STAFF RECOMMENDATION

2206 White Avenue

December 21, 2016

Application: New construction—infill and outbuilding

Figure 1. Existing house at 2206 White Avenue.

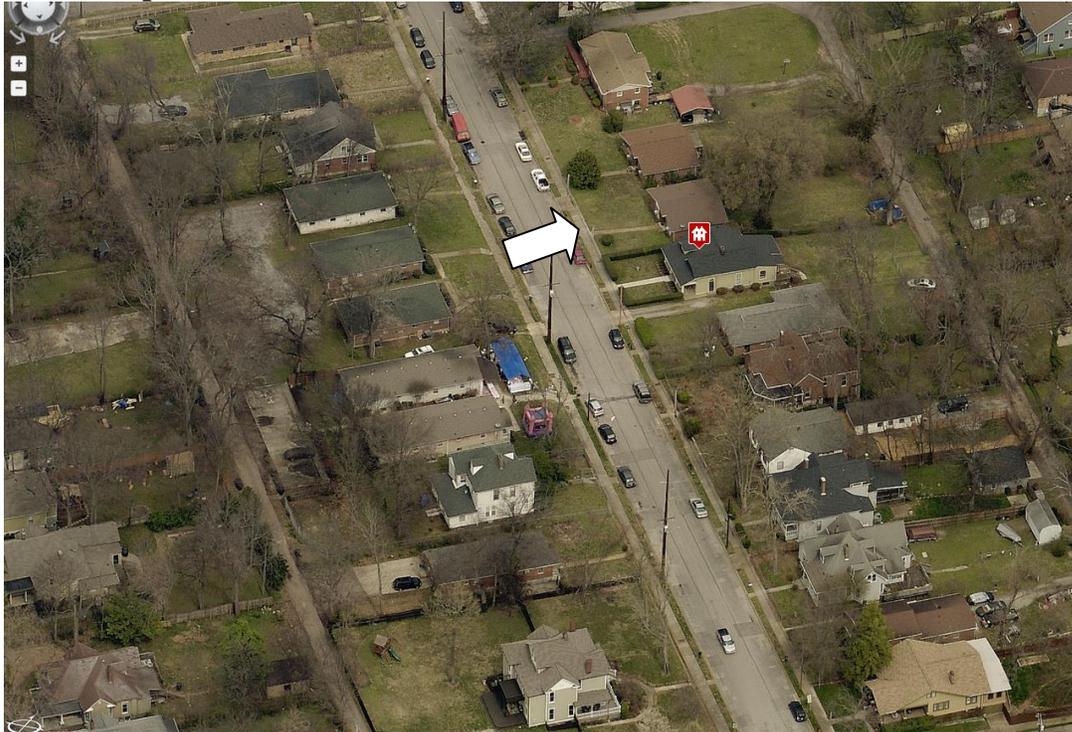
Background: 2206 White Avenue is a c. 1971 one-story residential structure that does not contribute to the historic character of the Woodland-in-Waverly Historic Preservation Zoning Overlay (Figure 1). In September 2016, MHZC staff issued an administrative permit to demolish the structure.

Figure 2. The side façade of the proposed infill, which has a wall of over eighty feet (80') long.

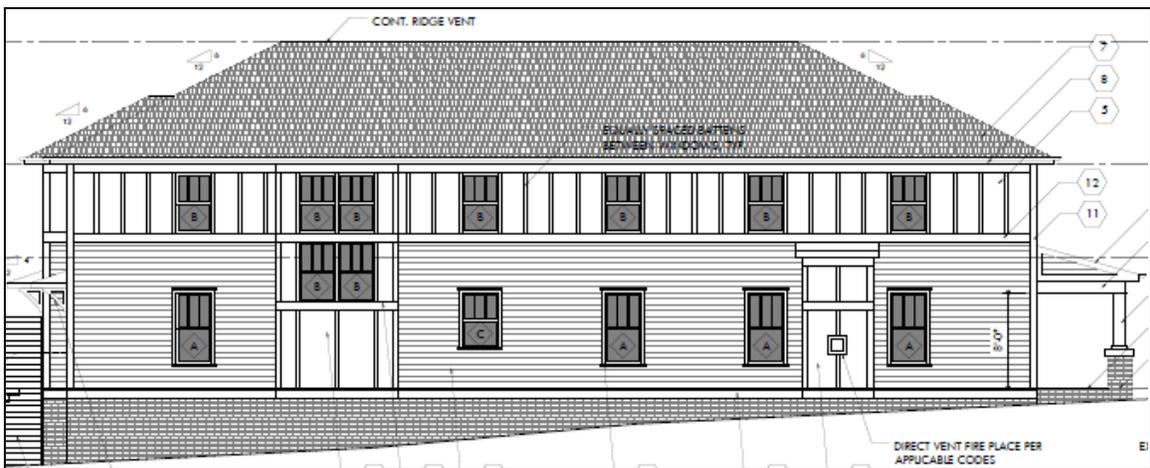
While the height and width and two-story form of the house may meet the historic context, the large depth of the house increases the overall scale so that the house overall is much larger than the other houses on the block. The proposed infill has a depth of eighty-one feet, four inches (81'4"), not including the eight foot (8') deep front porch (Figure 2). By comparison, the historic houses on the block have depths between fifty-three and fifty-eight feet (53'-58'). As an example, historic two story house at 2223 White Avenue has a height of approximately forty feet (40') and a width of forty-two feet (42'), but its depth is just fifty-three feet (53') (Figures 3 & 4).

Staff finds that the depth of the infill creates a structure that is out of scale with the historic context and is not similar to historic buildings in terms of “mass in relation to open spaces.” Staff therefore finds that the duplex does not meet Sections III.B.2.a and b. of the design guidelines. Because the scale of the house would have to be substantially

reduced and would likely require a re-design, staff does not recommend specific conditions to address the issue.

SITE PLAN
Sheet Number

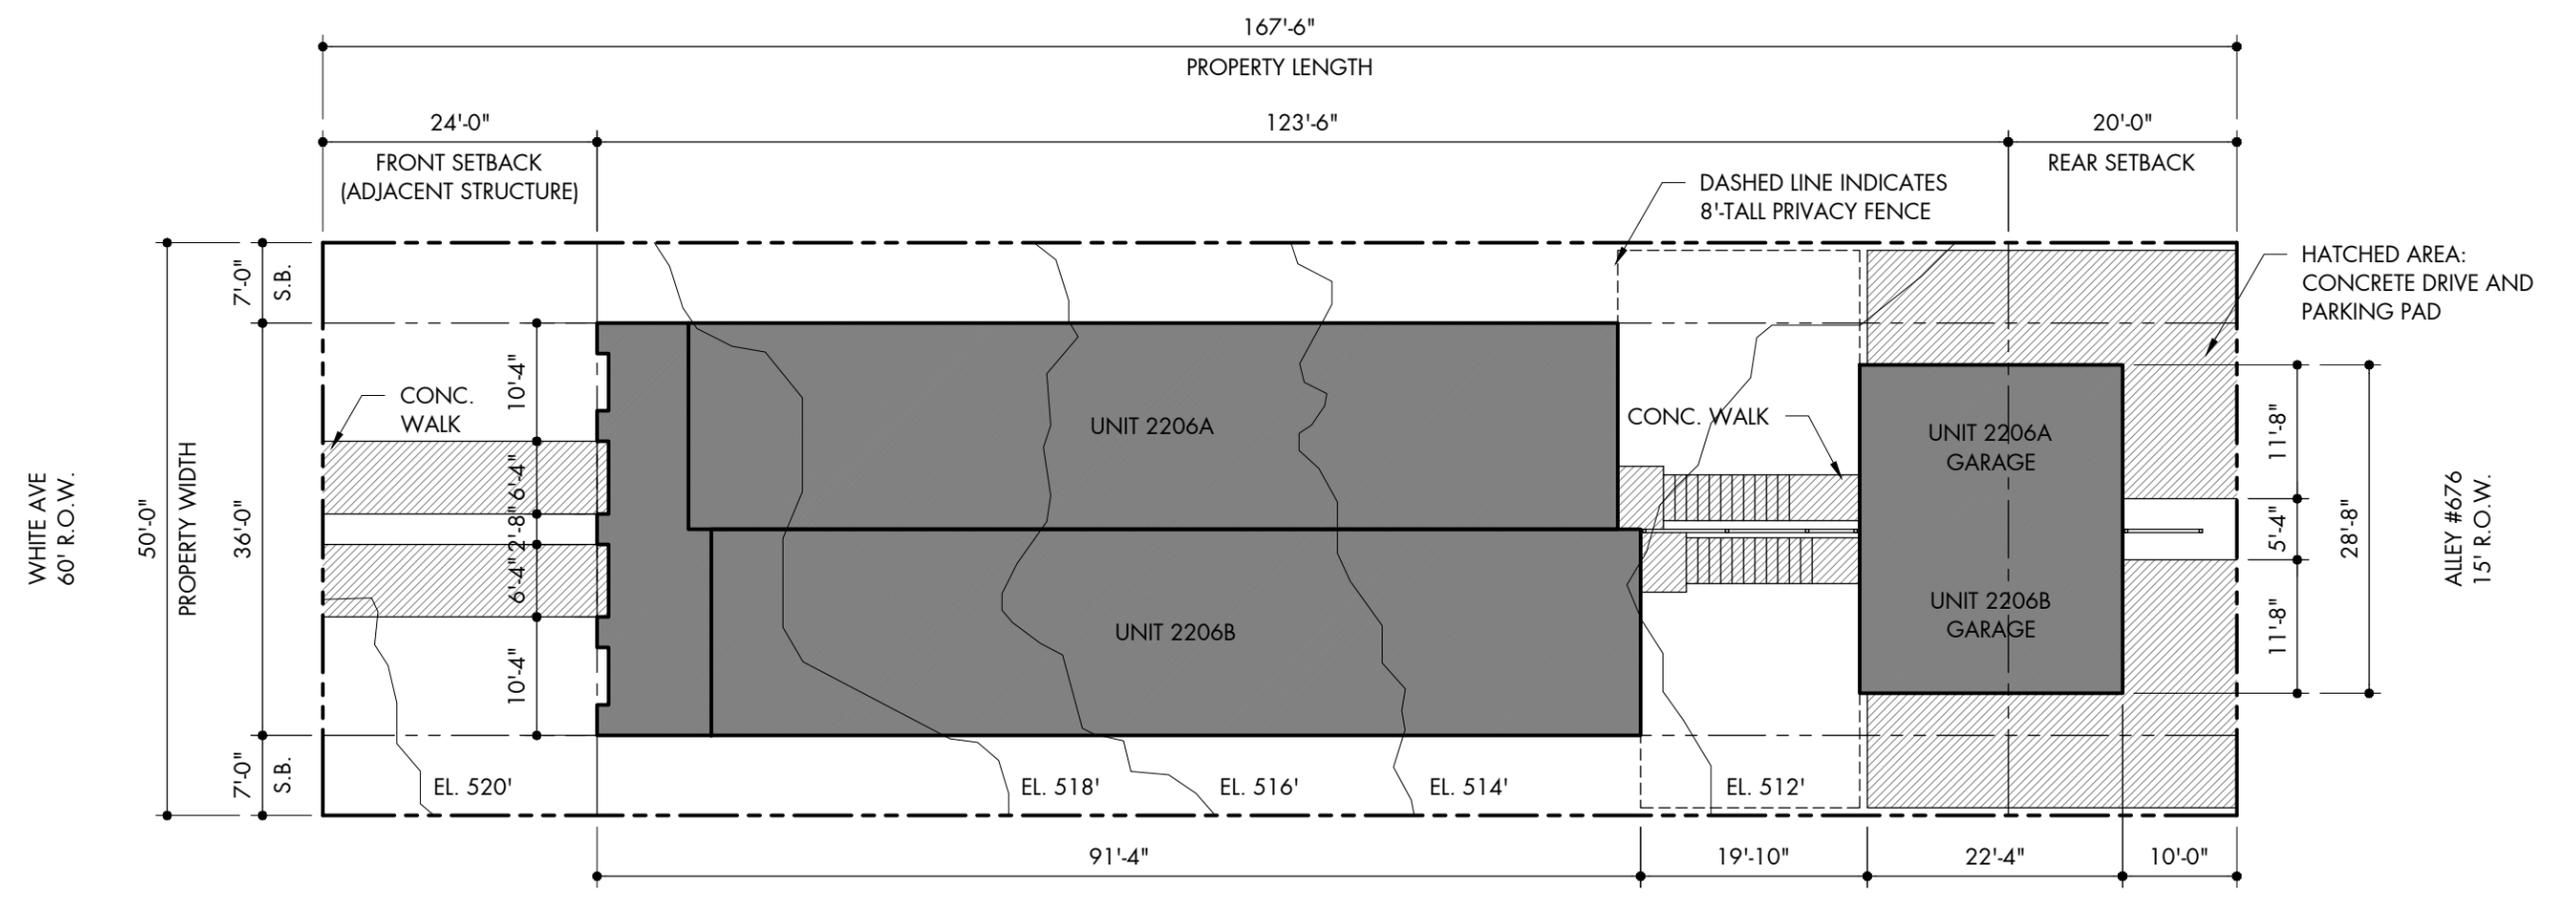
MINIMUM	PROPOSED
Space between principal building and DADU/Garage	20'	19'10"
Rear setback	10'	10'
L side setback**	3'	≈10'8"
R side setback**	3'	≈10'8"
How is the building accessed?	From the alley or existing curb cut	Alley.

The design guidelines require twenty feet (20') in between the primary structure and the outbuilding. The applicant is proposing nineteen feet, ten inches (19'10"). Since a condition of approval is that the infill be shortened, the space between the two structures will likely increase, which staff finds to be appropriate.

01 EXTERIOR ELEVATION
WEST (STREET ELEVATION)

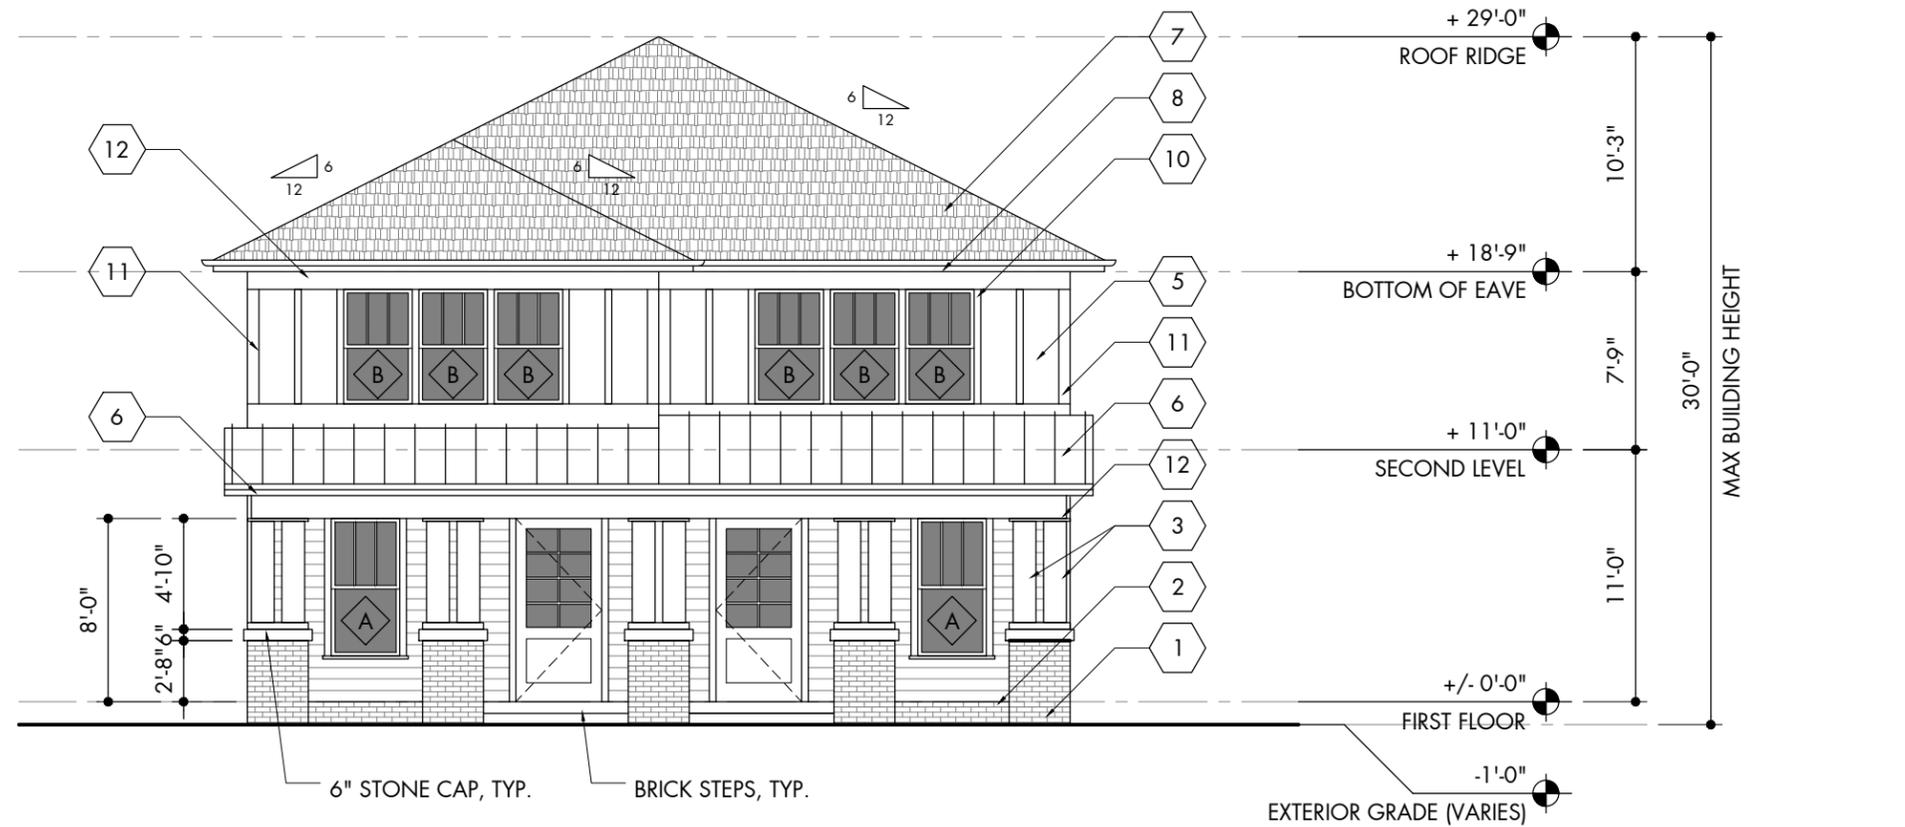
*The applicant is proposing six inch (6”) lap siding, but the design guidelines state that the siding reveal should be a maximum of five inches (5”). Staff recommends that the siding reveal be no more than five inches (5”) in the redesigned project.

**There is a change of material at upper portion of the house from lap siding to board and batten. The change occurs above the second floor line, but typically changes in materials happen at the floor line. In the redesign, staff recommends that the change in material be lowered so that it occurs at the second floor line rather than above it.

***The applicant is proposing to have brick front steps and a brick porch floor. Staff recommends that in the redesign, the porch floor and steps be concrete, as concrete is more historically appropriate.

In order for the project to meet Section III.B.2.d. of the design guidelines, the lap siding would have to have a maximum reveal of five inches (5”), the change in material would have to occur at the second floor level, and the front porch steps and floor would have to be concrete. In addition, staff would have to approve a brick sample, the shingle color and texture, the standing seam metal roof color and texture, and all windows and doors prior to purchase and installation.

GARAGE
 ELEVATIONS
 Sheet Number

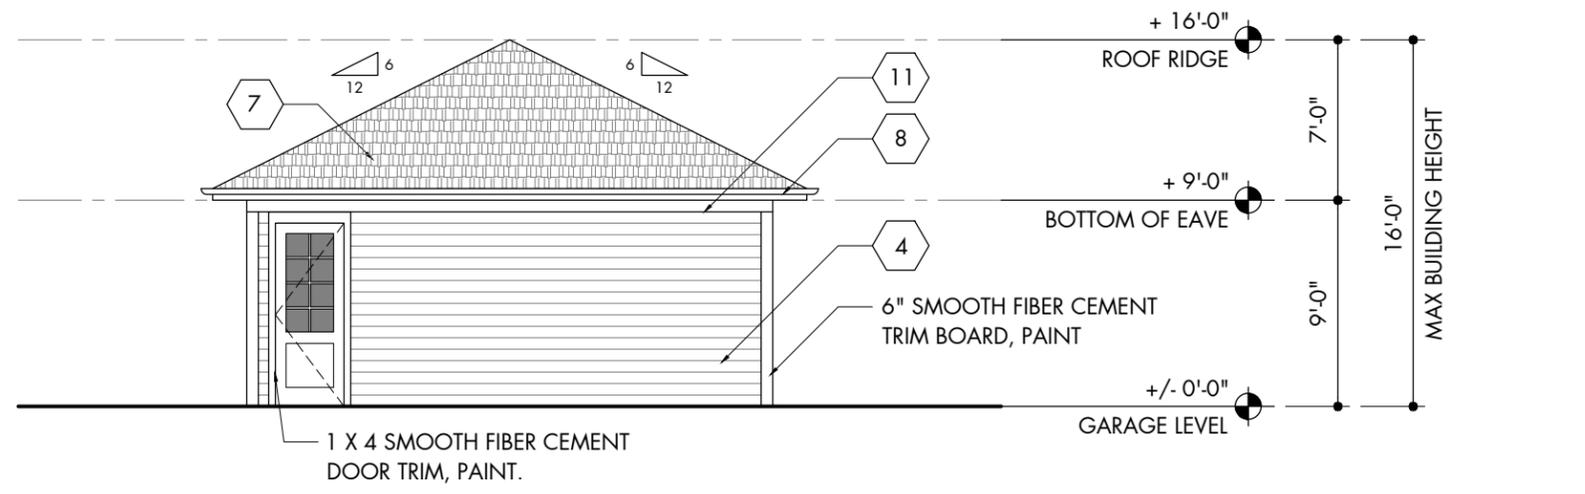
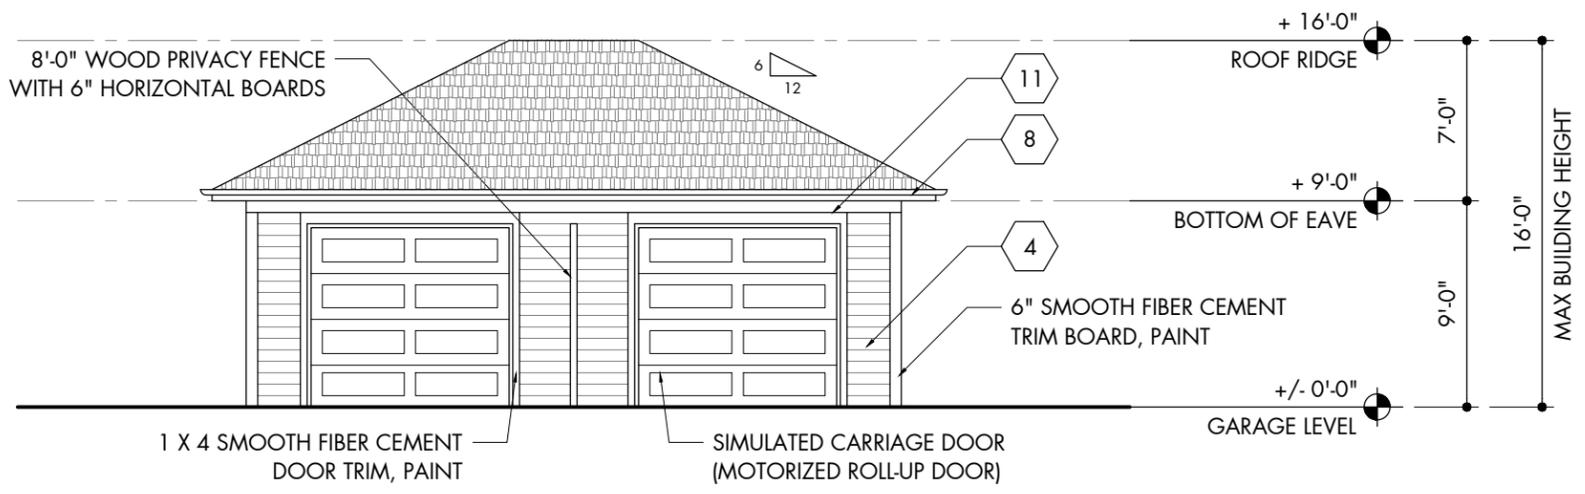
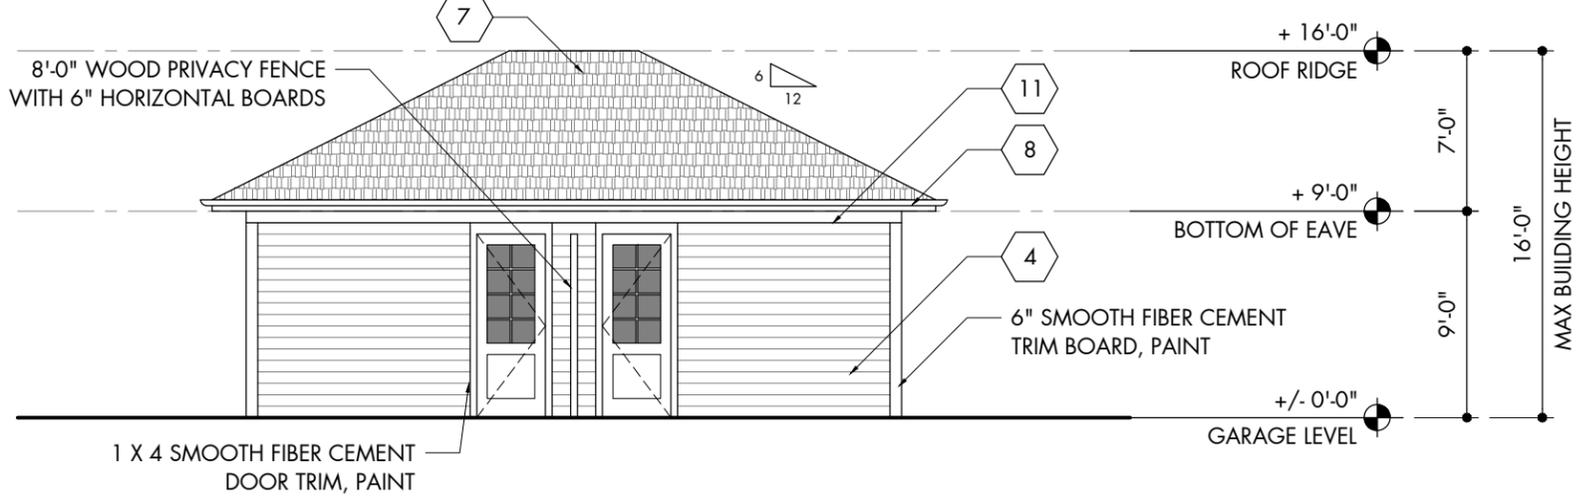
* As mentioned under the materials for the infill, the design guidelines state that lap siding shall have a maximum reveal of five inches (5"). Staff recommends that the lap siding for the garage also have a maximum reveal of five inches (5").

With this condition, and the staff's final approval of the doors, staff finds that the known materials meet Section III.B.2.h. of the design guidelines.
